Government of India
Central Electricity Authority
Southern Regional Power
Committee
29, Race Course Cross Road
Bengaluru - 560 009

Sub: Minutes of the 145th Meeting of Protection Coordination Sub-Committee (PCSC-145) held on 07th August, 2026.

It is informed that **Minutes of the 145th Meeting of PCSC** held on **07th August, 2026** have been uploaded on the SRPC Website (srpc.gov.in). All Constituents are requested to kindly take suitable action w.r.t. **PCSC-145** recommendations as applicable to them.

22. Repeated through-faults leading to failure of ICT in SR -Review/Study

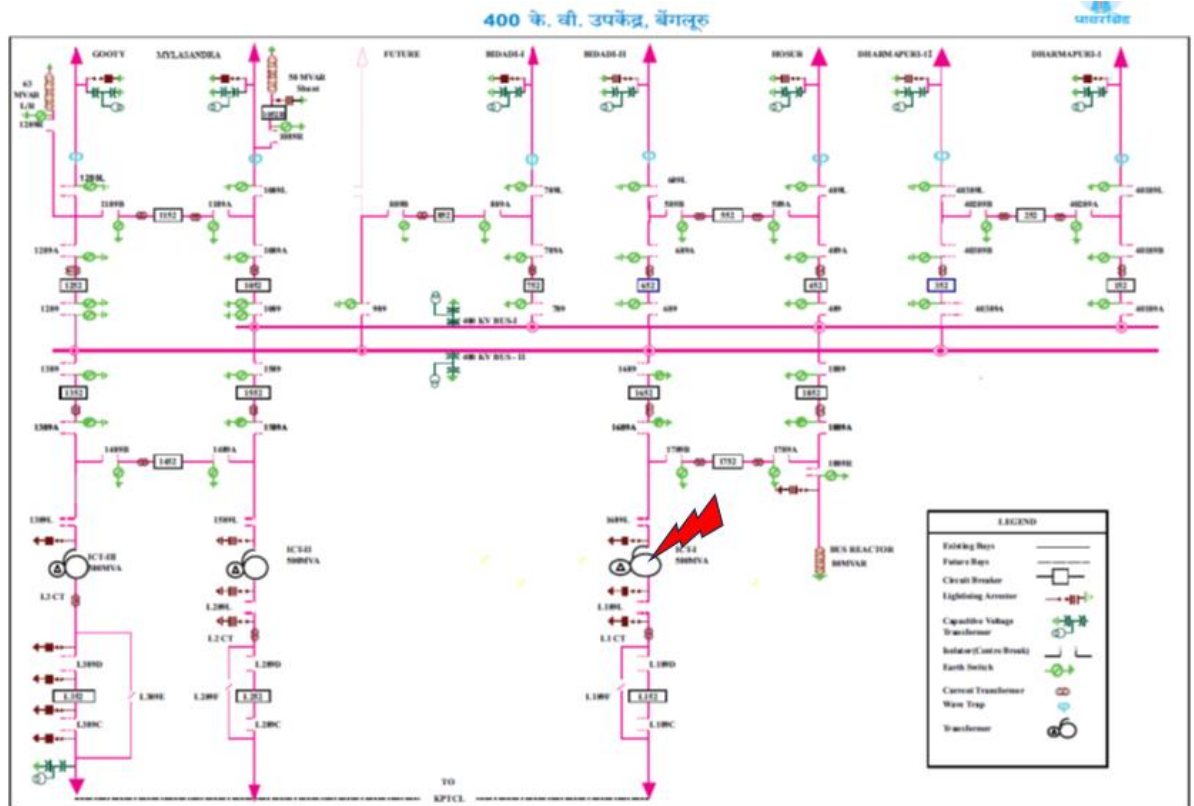
The 500 MVA, 400/220 kV ICT-I at PGCIL Somanahalli Substation failed on 31.05.2026 following repeated downstream faults in the 220 kV KPTCL network. During the OCC deliberations, it was observed that the ICT had experienced multiple downstream fault incidents, including prolonged fault-current feeding and repeated through-fault stresses. The failure highlighted the need to examine the protection coordination, fault-clearing times, bus-section operating practices, test-charging procedures and the adequacy of protection arrangements for ICTs directly connected to downstream networks owned by other utilities.

The OCC Forum decided that the matter may be placed before the **Protection Sub-Committee (PSC) of SRPC** for detailed technical examination and deliberation. The Committee may examine the occurrence of similar incidents across the Southern Region, including the Somanahalli ICT failure, Madurai ICT Failure, Nunna ICT Failure.

23. SRLDC Agenda item - Non-Compliance of Under-Frequency Protection Settings of GREENKO PSP Generating Units

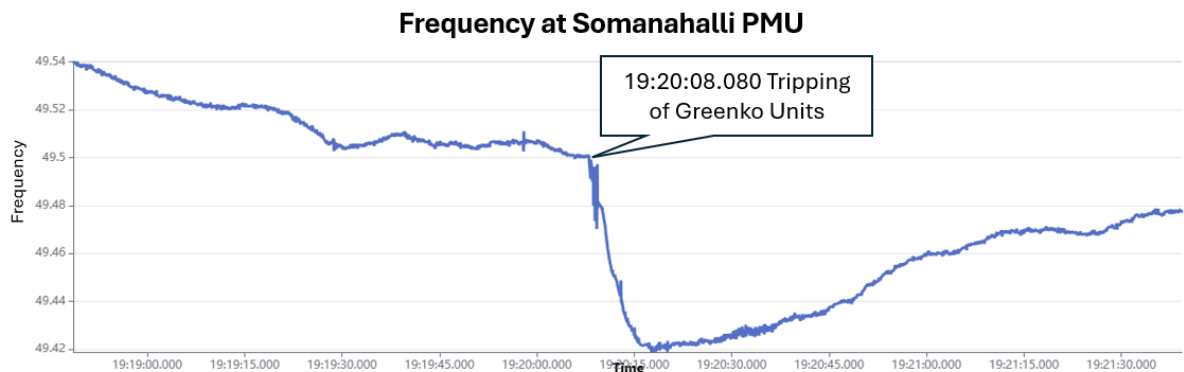
Reference is invited to the deliberations held during the 143rd Protection Coordination Sub-Committee (PCSC) Meeting held on 08-06-2026 regarding the review and compliance of under-frequency and over-frequency protection settings of Pumped Storage Plants (PSPs) in line with the IEGC Regulations, CEA (Technical Standards for Connectivity to the Grid) Regulations, and the AUFLS Scheme.

During the 143rd PCSC meeting, GREENKO informed the forum that the under-frequency protection setting for units operating in generation mode was 48.0 Hz and the over-frequency protection setting was 52.0 Hz with a time delay of 1 second, while confirming that the under-frequency protection setting for units operating in pumping mode had been revised to 49.5 Hz for 5sec. Based on the information furnished by GREENKO, the Committee deliberated that the revised under-frequency setting of 49.5 Hz with a near-instantaneous time delay of 50–75 ms was applicable only to pumping mode, whereas the protection settings for units operating in generation mode should comply with the provisions of the CEA (Technical Standards for Connectivity to the Grid) Regulations, which require generating units to remain connected to the grid for system frequencies down to 47.5 Hz and necessary protection modification is to be done in consultation with their OEM. Accordingly, GREENKO informed the forum that the generation-mode protection settings would be reviewed with the OEM and modified to ensure compliance with the applicable regulations.

However, during the subsequent event on 25.07.2026 at 19:20 hrs, when the system frequency declined to approximately 49.5 Hz, all five generating units of GREENKO PSP operating in generation mode tripped simultaneously on under-frequency protection, resulting in a sudden generation loss of approximately 1200 MW. The loss of generation further aggravated the disturbance, causing the system frequency to decline to around 49.42 Hz.
